## Comment Letter #59

### California Council for Environmental and Economic Balance

RE: Comments on the Draft 2022 Air Quality Management Plan (AQMP)

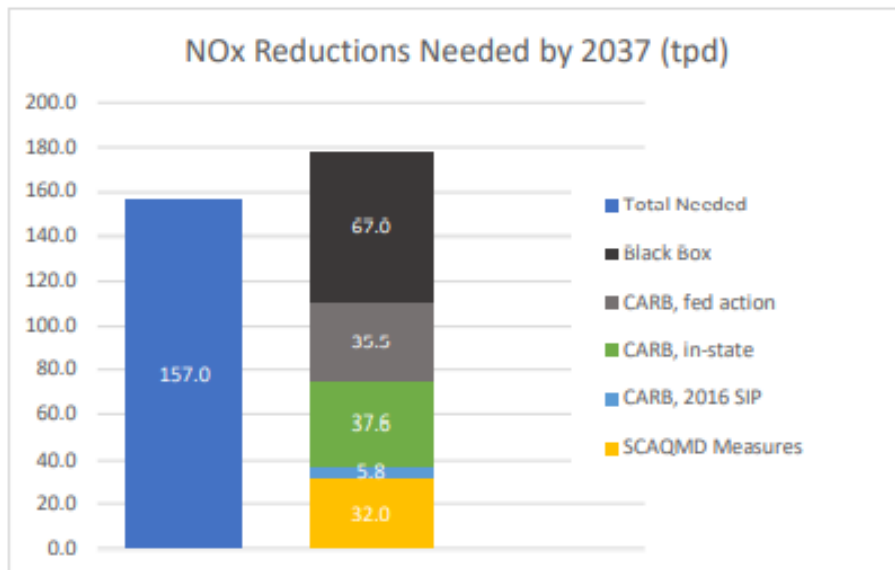
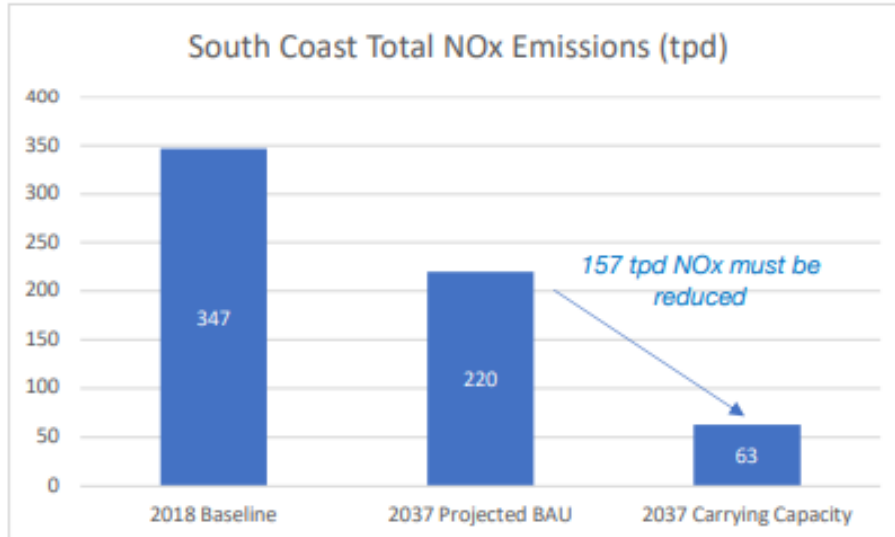
To understand why CARB and federal sources are at the core of any attainment strategy, we look at the relative contribution of different source categories and jurisdictional responsibilities, as shown in Figures 3-3 and 3-4, respectively (2018 inventory).<sup>6</sup>

This disconnect between who controls the sources most needed for attainment (the federal government) and who ultimately bears responsibility (South Coast and the State) poses a major challenge to the AQMP.

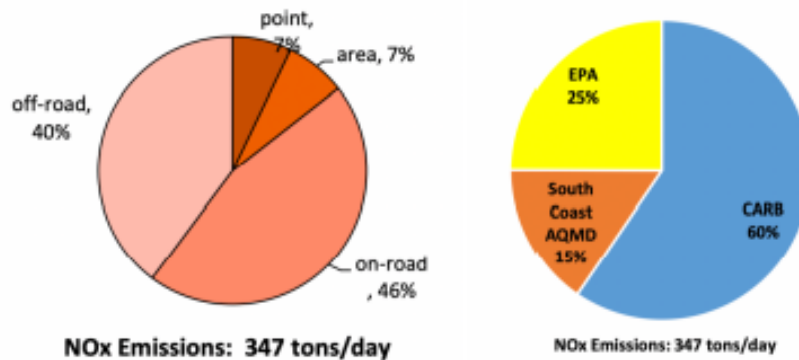
To better illustrate this point, we take a high-level view of the numbers, based on information given in the draft AQMP.<sup>5</sup>

<sup>5</sup> Total NOx Emissions are from Figure 5-9. Black Box data is from Figure ES-7. CARB measures are calculated from Tables 4-8 and 4-9. SCAQMD measures are calculated from Tables 4-2 and 4-3. However, we note there are several seeming discrepancies across the figures and tables provided for CARB emissions. For example, Figure ES-7 indicates that "Defined Measures" total 90 tpd, but it is unclear how this was calculated based on quantified reductions for each measure. Also, Figure 4-5 shows 6 tpd of reductions from "passenger vehicles" but Table 4-9 indicates only 0.9 tpd from "On-Road Light-Duty," a possible discrepancy of 5 tpd. Adding to this data confusion is that fact that CARB uses a 2012 baseline inventory in its *Draft Environmental Assessment: Attachment A, Environmental and Regulatory Setting*.
